## Defining Away the Hazard: The Department of Energy's Solution to the High-Level Waste Problem at INEEL

**Defining Away the Hazard**  
**The Department of Energy's Solution to the High-**  
**Level Waste Problem at INEEL**

By Marvin Resnikoff and Beat Hintermann  
Radioactive Waste Management Associates

On Behalf of the Snake River Alliance

Figure 6. DOE-diagram that shows the proposed tank closure for the Performance-based Closure Alternative<sup>146</sup>.

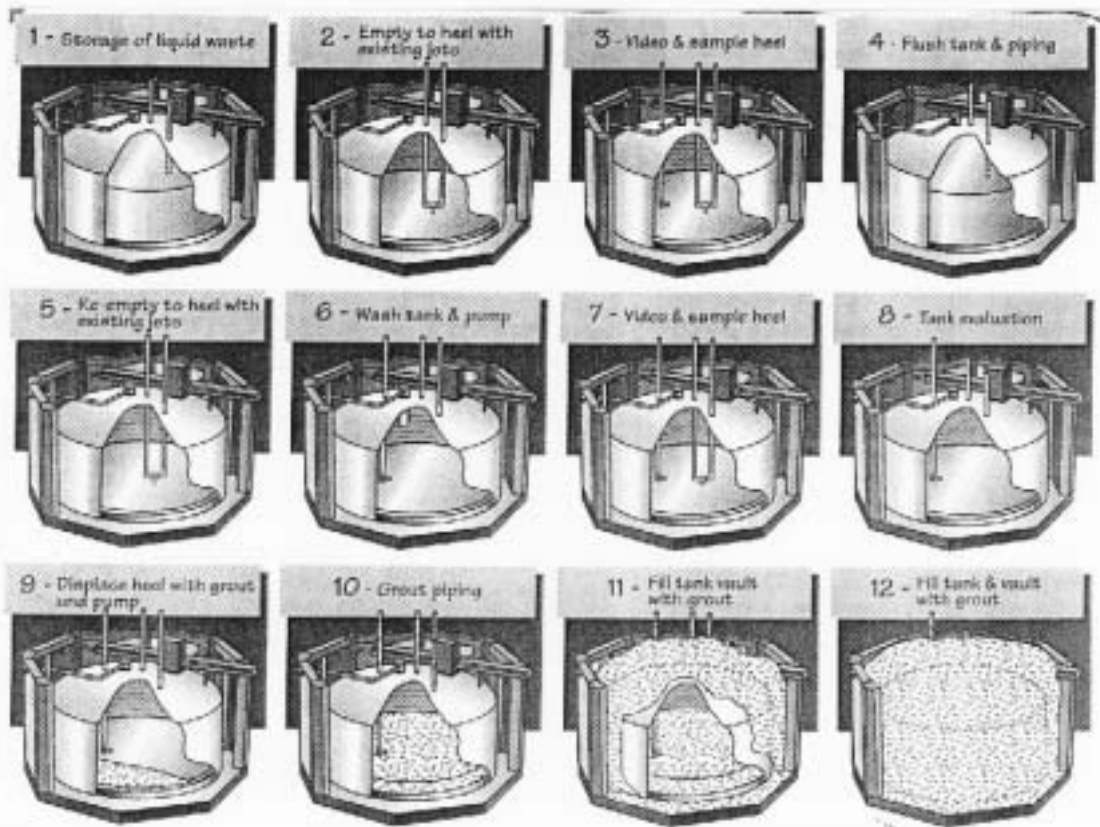
After this first disc of grout in the tank, the space between the vault and the tank, and finally the entire vault and tank are filled with grout. Fig. 6 shows a DOE diagram of the planned tank closure. The resulting monolith would be left in place forever.

After placement, the grout will be irradiated for many years. It is very difficult to foresee how it will react to such a prolonged exposure. Besides the physical integrity, the grout could also lose some of its chemical integrity. The claim of stable chemical characteristics translates into a claim of stable distribution coefficients (Kd's), because the Kd's depend on the valence state of an element, which in turn is controlled by the chemical properties of its surroundings. Thus, if the chemical properties of the grout change over time, the valence state and therefore the distribution coefficients of the waste will change as well. Also, once contaminants are leached out of the tanks, the reducing ability of the grout would have no more influence on the waste even if it persists, and the radionuclides' Kd's could change with a changing pH.

Even if INEEL's assumption of very low conductivity during 500 years were realistic, it is questionable whether the radionuclides would remain in place. If conductivity is sufficiently low, diffusion through the pore network is the limiting factor for the movement of radionuclides<sup>95</sup>. WVDP considered this fact and calculated the waste flux from its HLW tanks by diffusion as opposed to the flux from other facilities that were not separated from groundwater by concrete, where a conductivity-limited flow was assumed.

While we have no reason to doubt the accuracy of the model itself, we question the applied assumptions. As mentioned above, the vaults do not currently prevent 29,000 gallons/y of water seeping into them. Also, as indicated earlier, it is very uncertain that concrete remains in perfect shape during 500 years and hence blocks water effectively from the zone beneath the tanks.
